TENNESSEE VALLEY AUTHORITY

SUBJECT: WATTS BAR NUCLEAR PLANT (WBN) - OPERATIONAL READINESS REVIEW PHASE III -
NUCLEAR SAFETY REVIEW STAFF (NSRS) REPORT NO. R-84-15-WBN

TENNESSEE VALLEY AUTHORITY
NUCLEAR SAFETY REVIEW STAFF
NSRS REPORT NO. R-84-15-WBN

SUBJECT: OPERATIONAL READINESS REVIEW - PHASE III

FIGURE 1

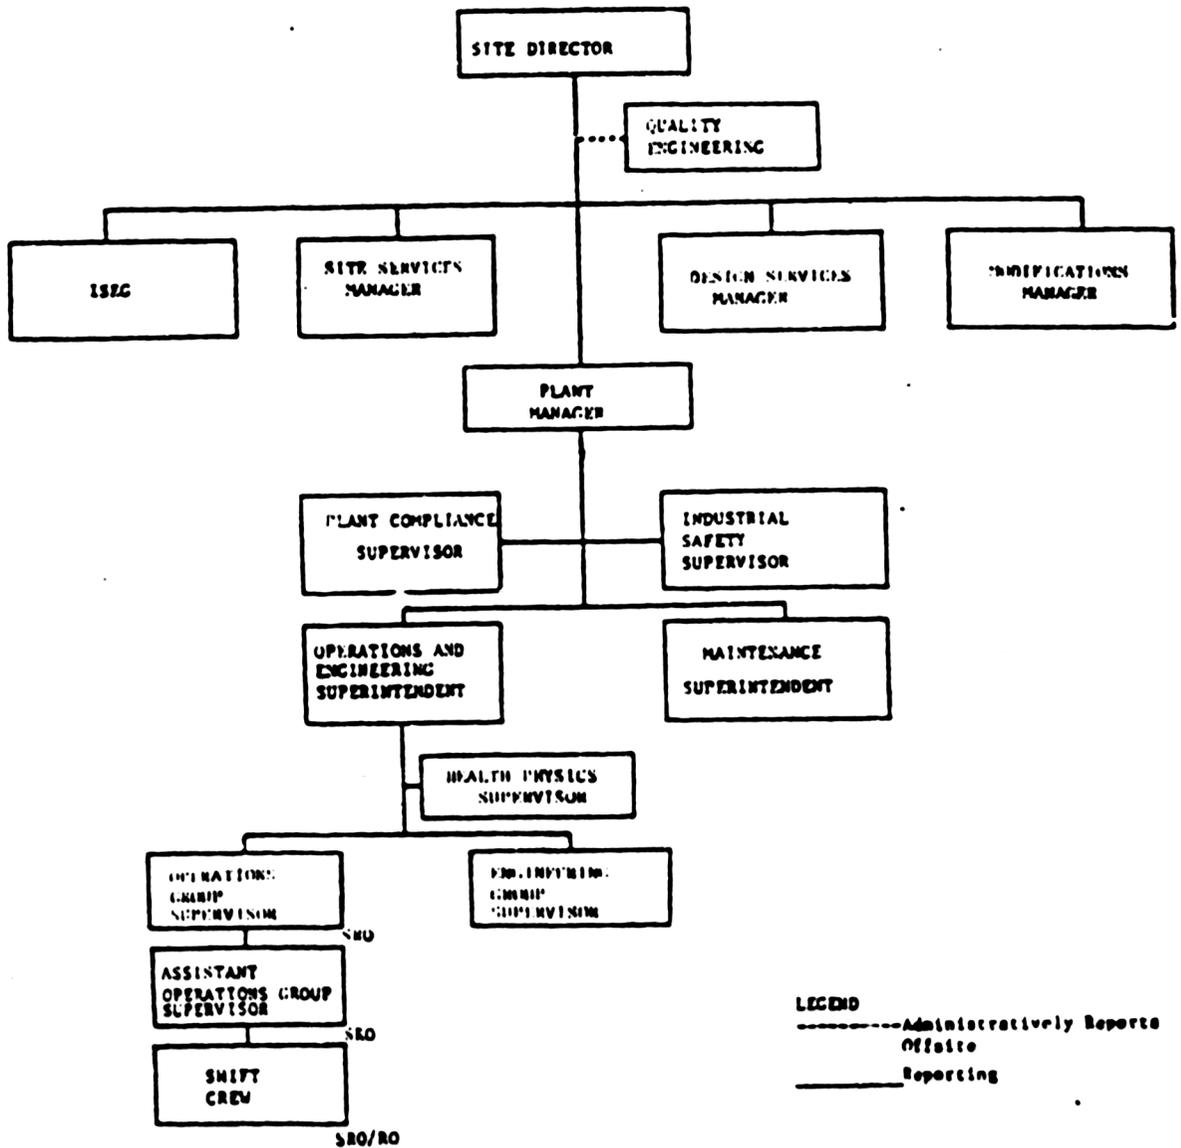
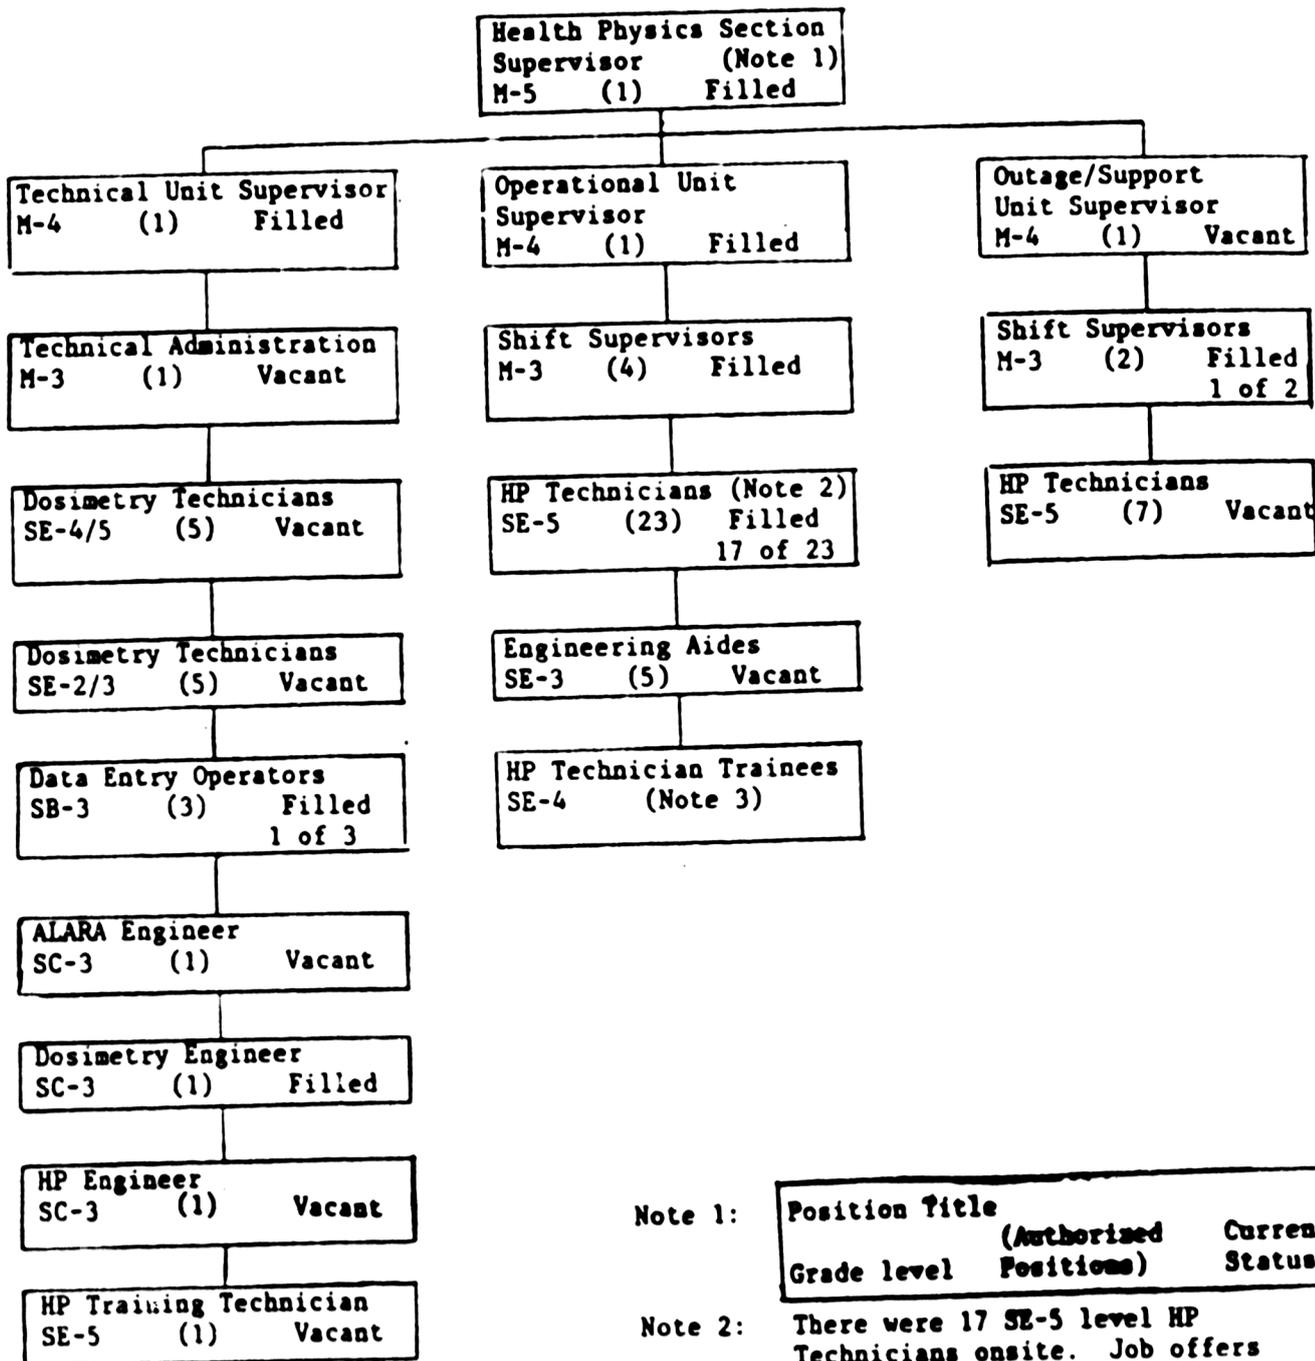
The plant organization does not provide the plant Health Physics Section independence from line operational pressures and organizational flexibility to deal directly with all aspects of the plant health physics program. The reporting chain of the Health Physics Section supervisor is through the Operational and Engineering superintendent to the plant manager. See section VI.B.6.c for details.

NSRS recommends that the plant organization be revised to establish the reporting chain of the Health Physics Section supervisor directly to the plant manager.

The current reporting chain of the Health Physics Supervisor is depicted by Figure 1 of this report. The Health Physics Supervisor reports through the Operations and Engineering Superintendent to the Plant Manager.
